August 16, 2023

RE: Remedial Action Work Plan – Addendum #1
737 4th Avenue, Brooklyn, New York
BCP #C224332

Figure

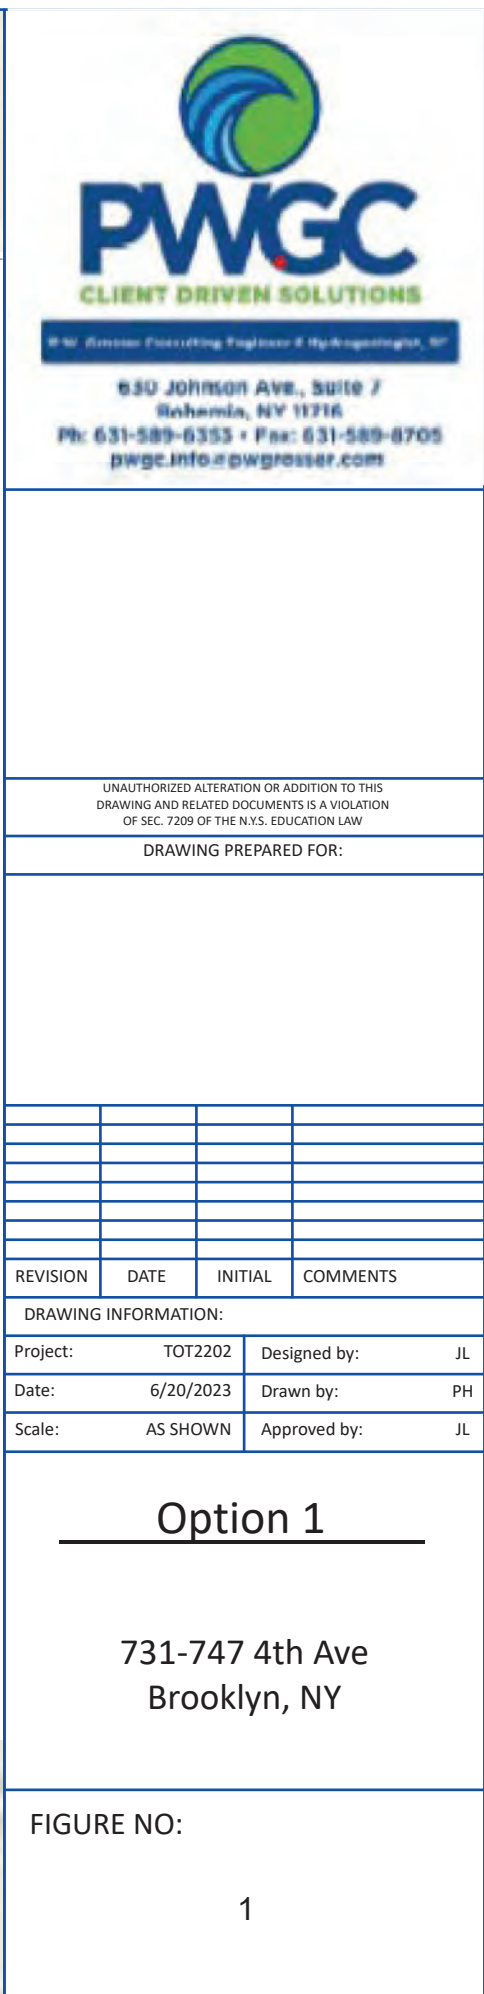
Proposed locations of the sentinel wells are included on **Figure 1**.

Proposed locations of the injection wells are included on **Figure 1**.

To evaluate/confirm drawdown of the water table interface and evaluate groundwater quality during dewatering operations, sentinel wells will be installed throughout the site. The sentinel wells will consist of 2-inch diameter PVC with 15 feet of screen and will be installed to a bottom elevation of +2 feet, so the screened interval will be between elevations +2 feet and +17 feet. The existing groundwater table is at approximately elevation +14 feet and the deepest area of dewatering is proposed to maintain the groundwater elevation at +5.5 feet. The sentinel wells will be finished with flush mounted monitoring well covers.

Injection wells are proposed to be installed as a precautionary measure to allow for future groundwater remediation in the event of contaminant migration resulting from dewatering operations. The injection wells will consist of 2-inch diameter PVC with 5-feet of screen and the screened interval will be placed between elevations +11 feet and +16 feet to capture the interval that the groundwater table is expected to return to once dewatering is complete. The injection wells will be finished with flush mounted monitoring well covers.

SUPPORT OF EXCAVATION
SECTIONS 02 13 2023

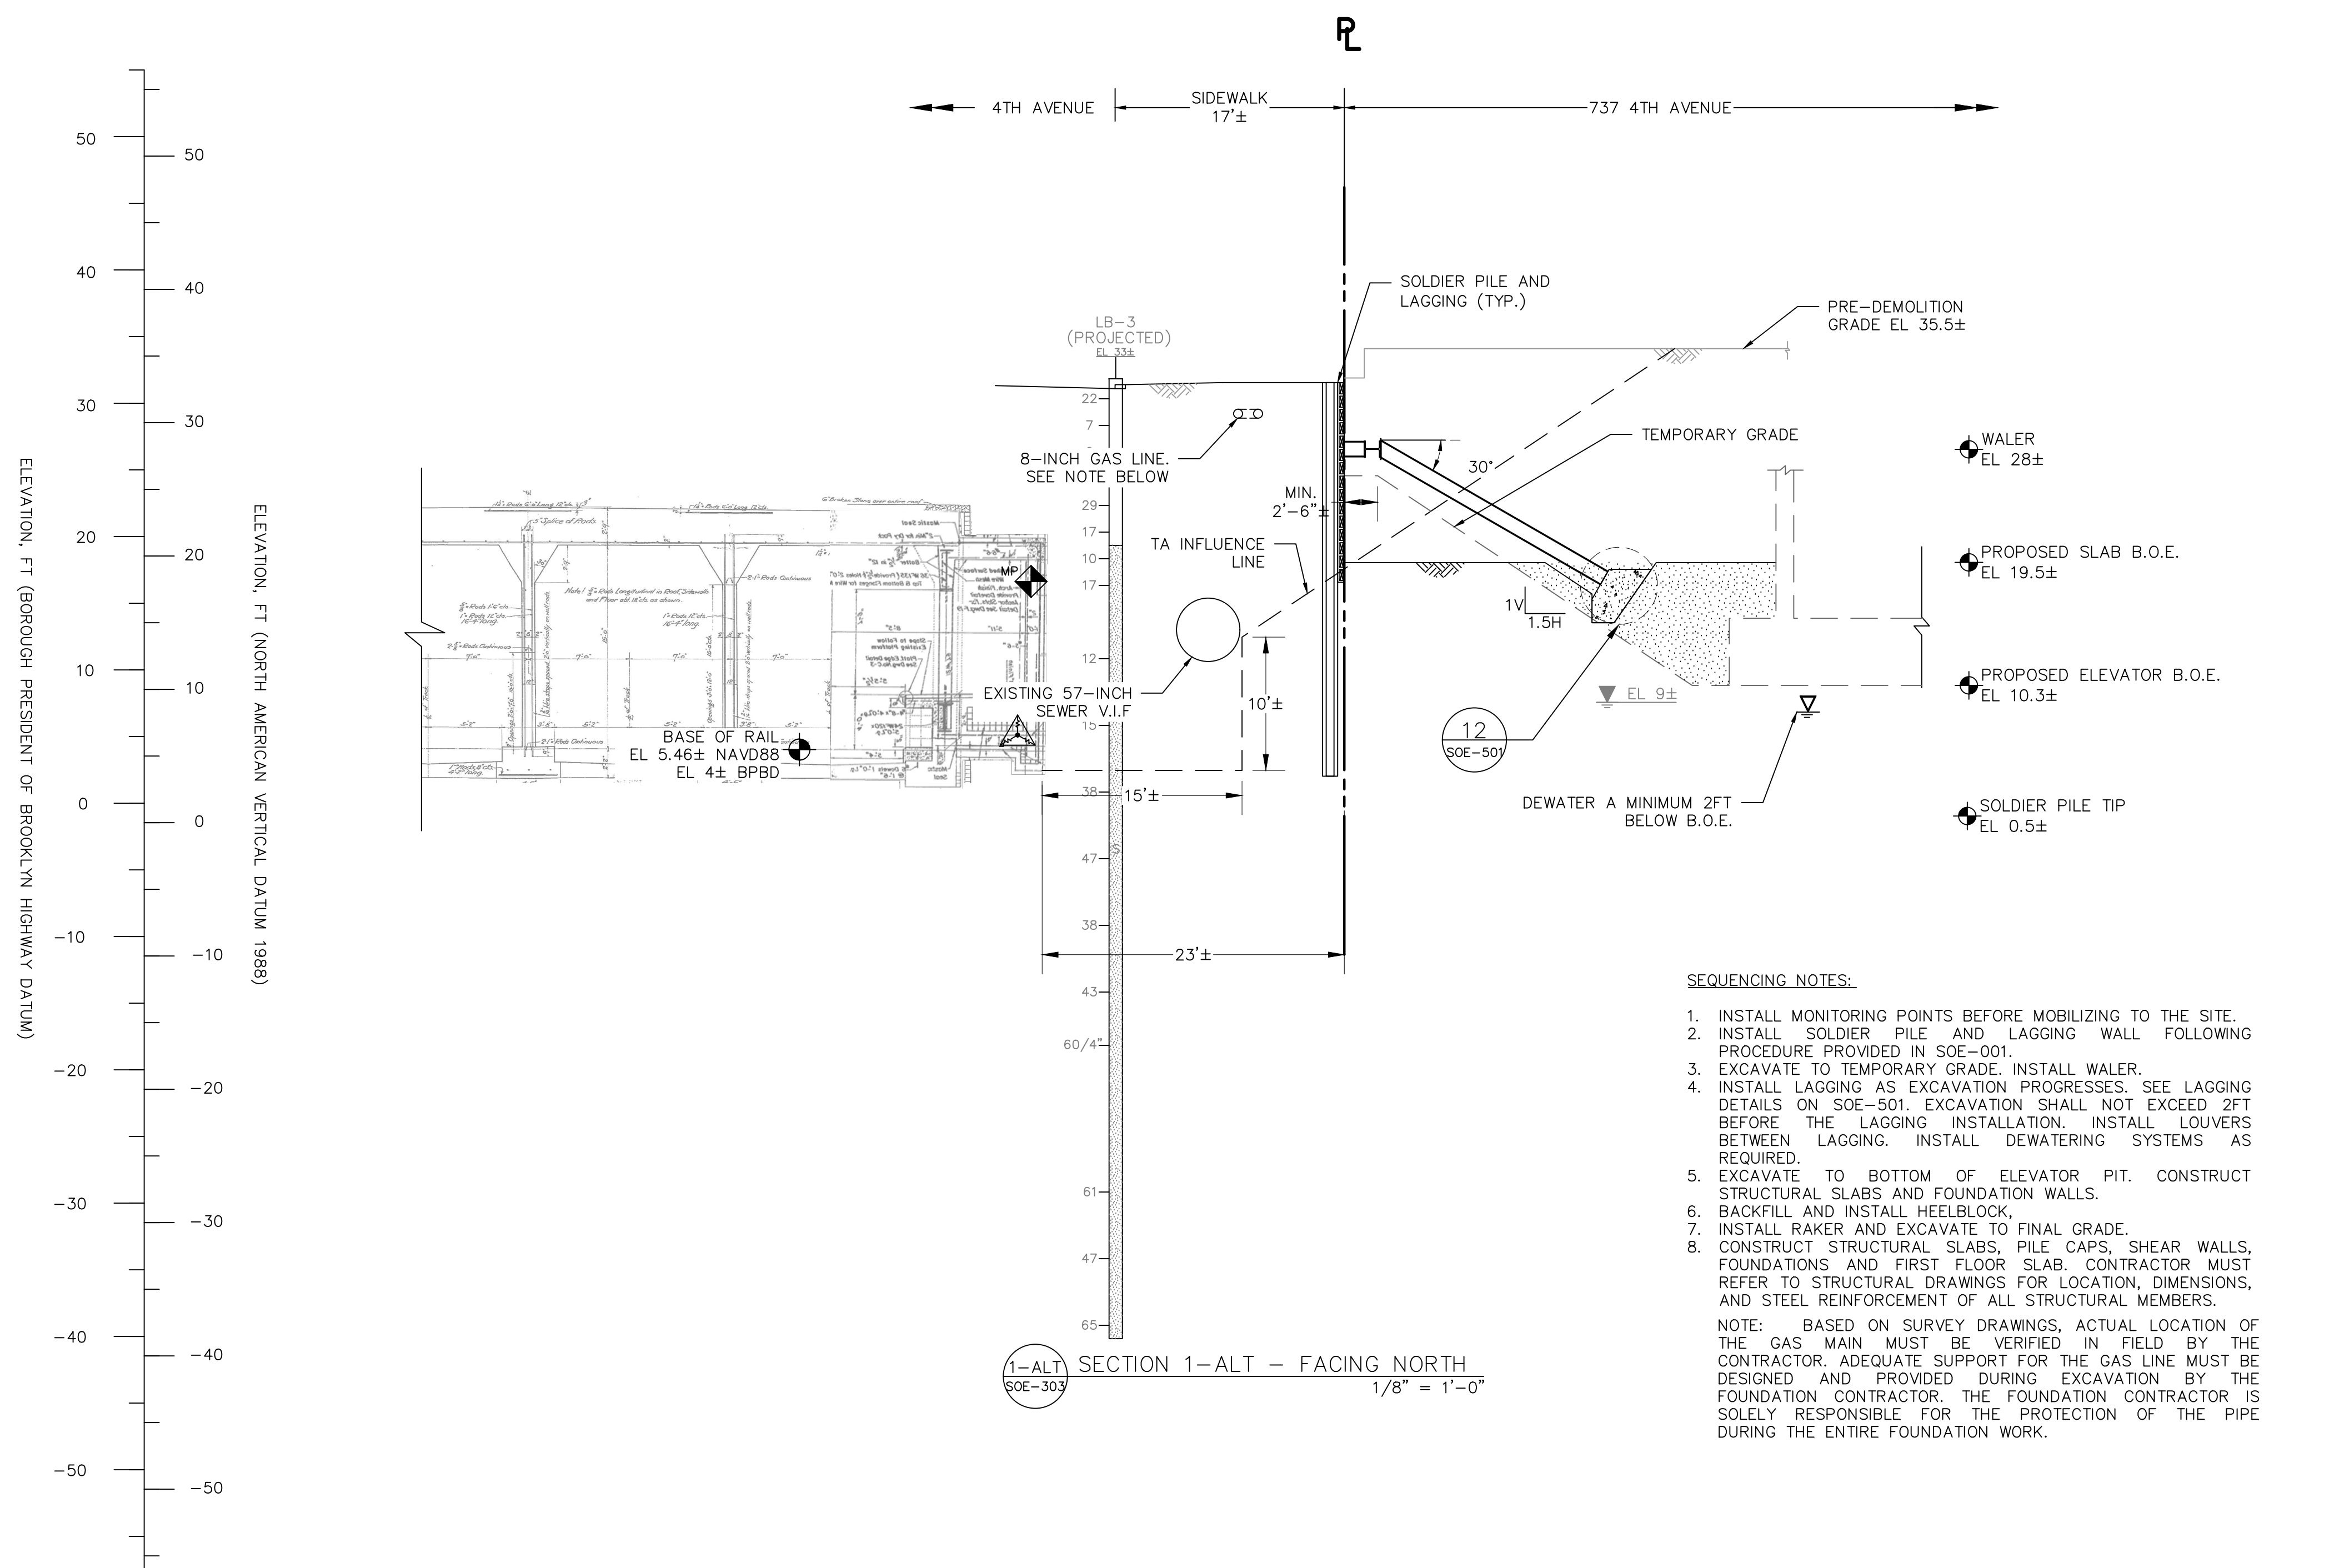
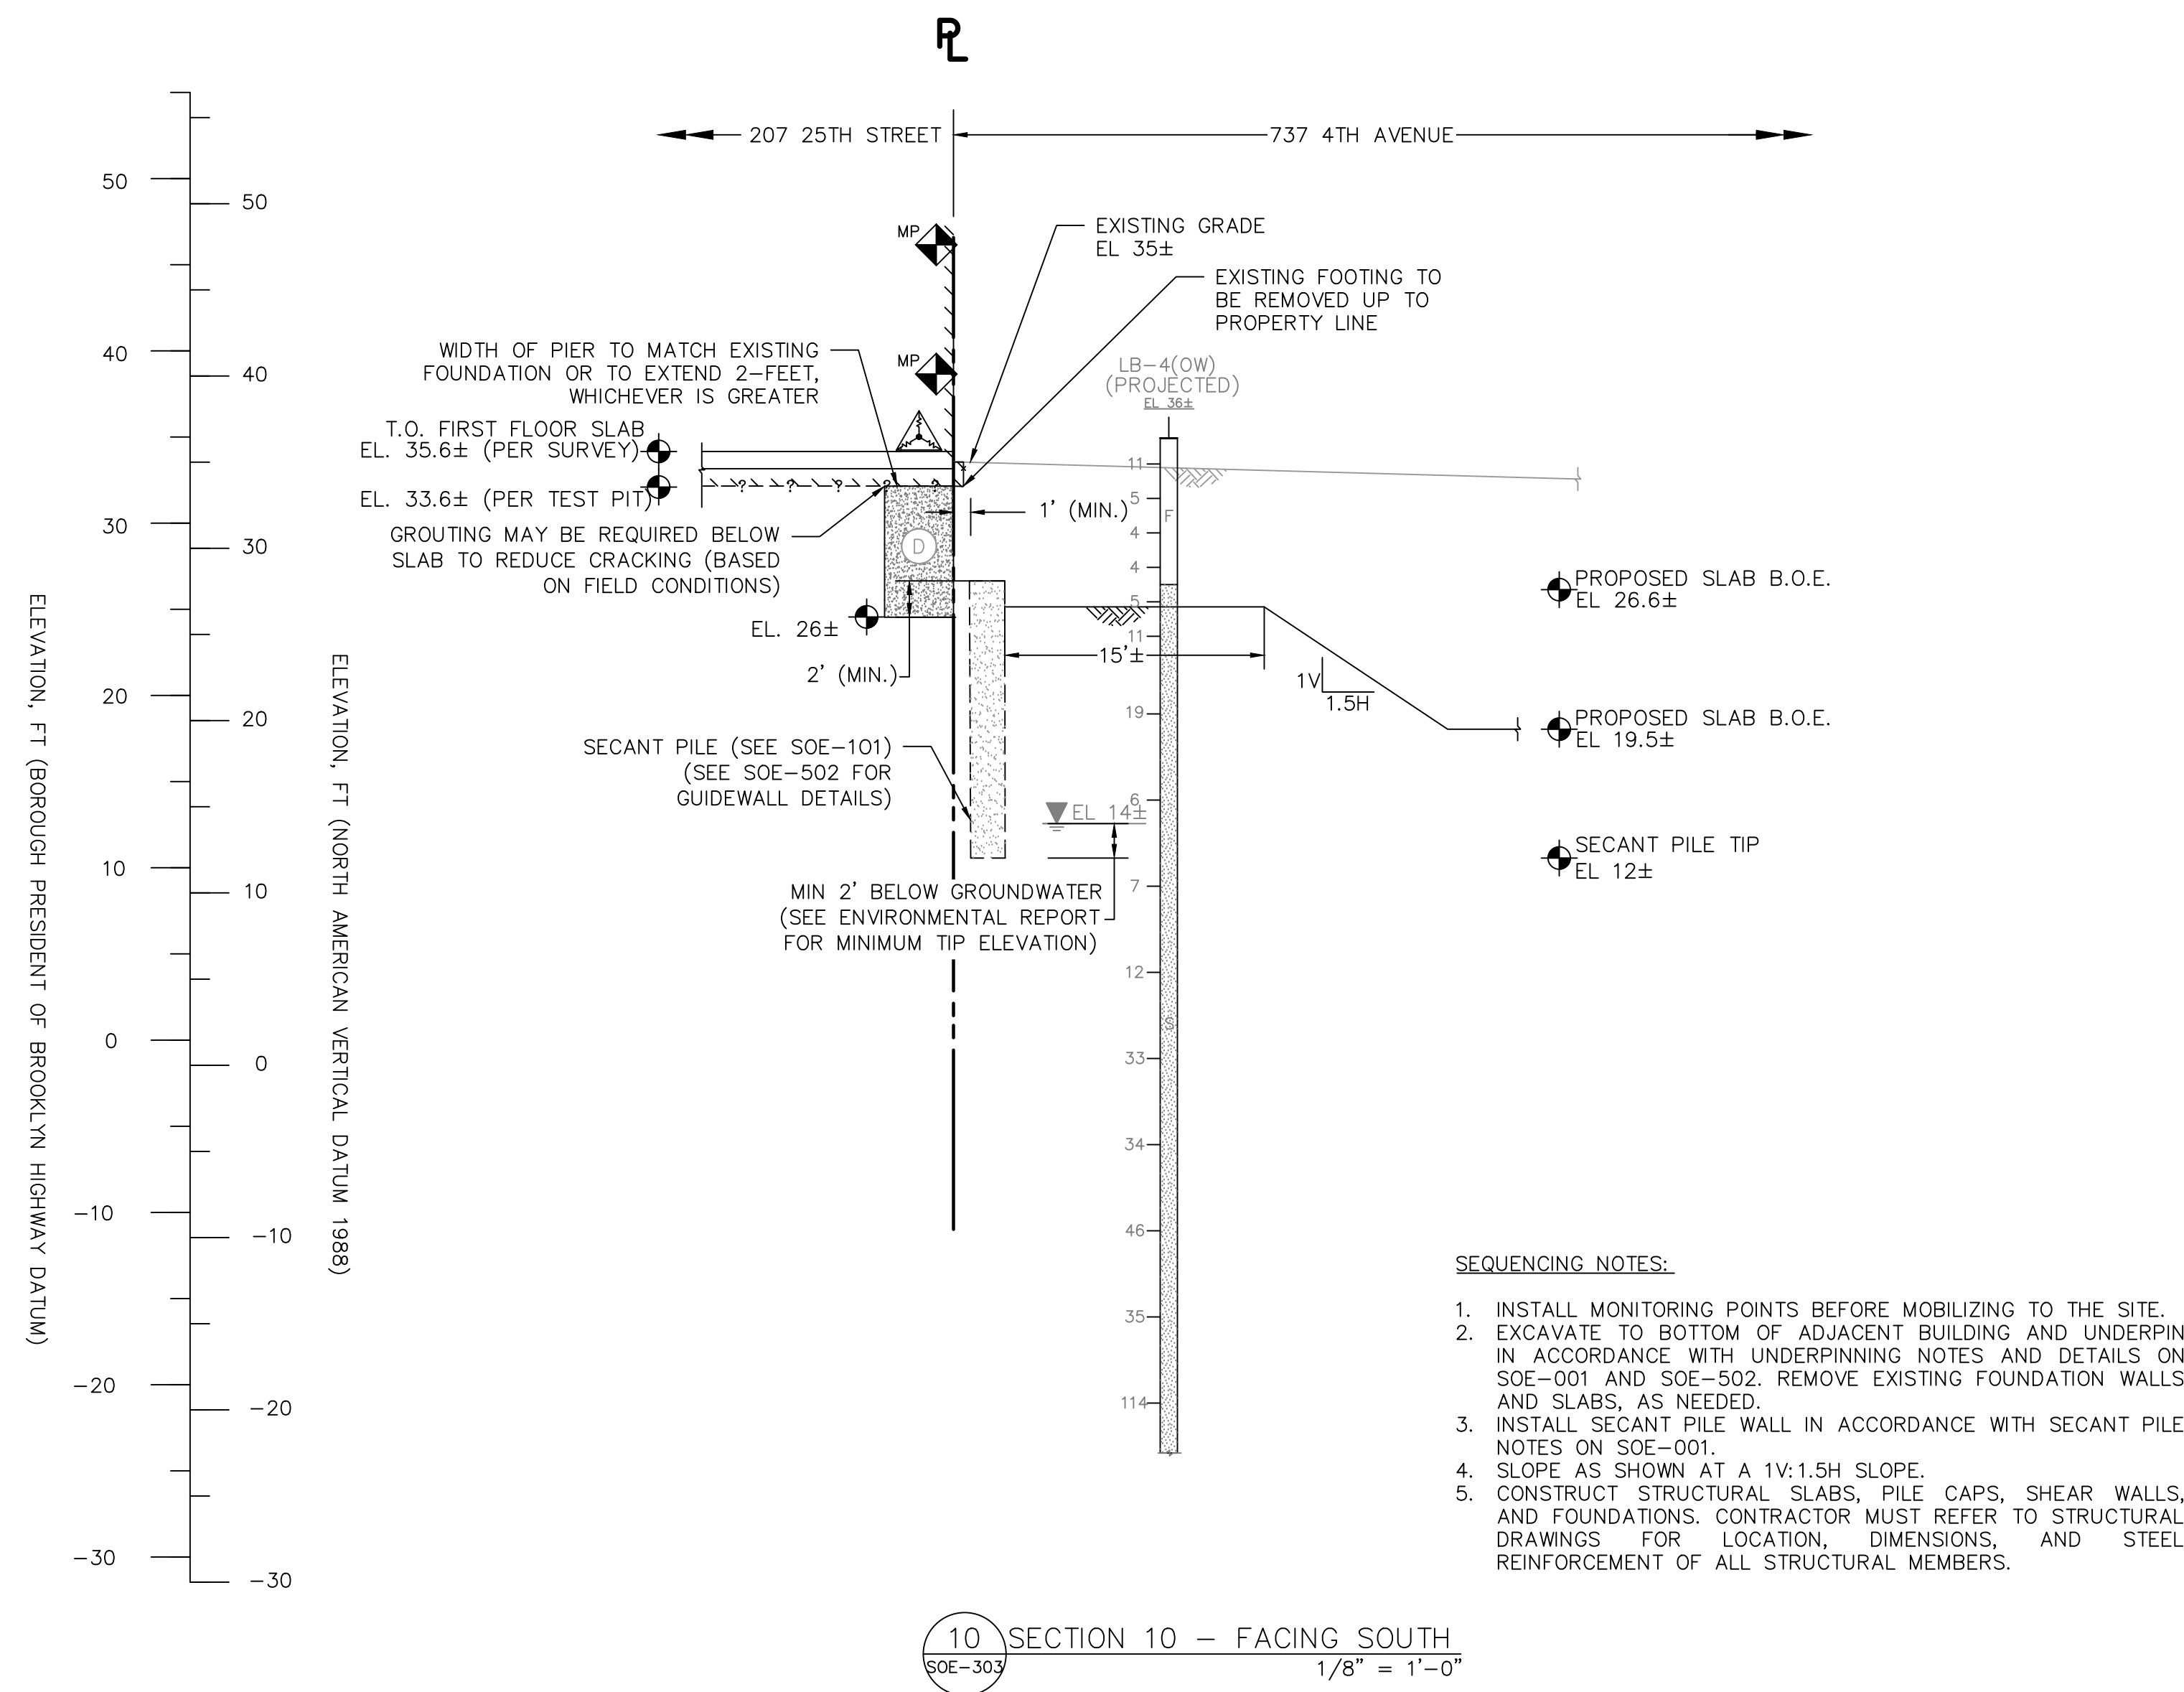
As outlined in the IRM Work Plan, a secant barrier wall is proposed to be installed along the shared property line with 207 25th Street. The secant piles are proposed to be installed to a minimum depth of two feet below the groundwater table elevation (+12) estimated at approximately elevation +14. The proposed design is included in **Attachment 1**.

Based upon the current dewatering model, drawdown is anticipated to elevation +12.5 at the southeast property line. The secant barrier wall depth will be at elevation +12. Based upon this design, any light non-aqueous phase liquid (LNAPL) is anticipated to be contained at the barrier wall and not migrate onto the property.
